From: Chris Holland
Sent: Friday, August 5, 2022 11:58 AM
To: Emily Morgan
Subject: FW: [External!] RE: Marysville 172nd (PA22017) - LNMP B.3(2)(a)(ii) & B.3(13)(c)
Attachments: Marysville Render_20220804.pdf

Subject: Marysville 172nd (PA22017) - LNMP B.3(2)(a)(ii) & B.3(13)(c)

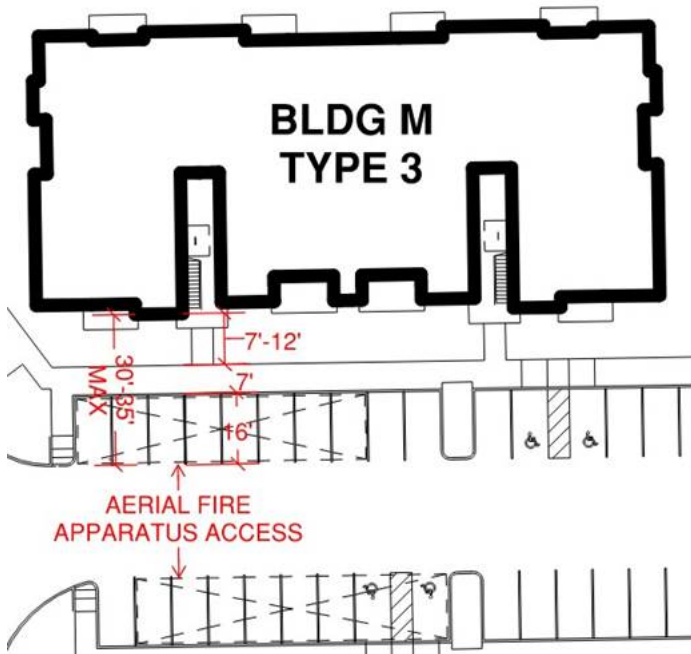
LNMP B.3(13)(c) Where the walkway is adjacent to ground level dwellings with windows facing the path, provide at least 15' separation between the window and the path.

The requirement for 15 feet of separation between ground floor windows and walkways directly conflicts with the Fire Code and Fire Marshal's requirement for 30 to 35 feet of maximum distance from the buildings to the Aerial Fire Apparatus Access. See the sketch below for an example at Building M showing 16-foot-long parking stalls and 7-foot walkways, which leaves 7 to 12 feet maximum between ground floor windows and sidewalks. We assume life-safety requirements govern in this case and that the 15-foot separation requirement can be reduced to 7 feet for the site. Please confirm.
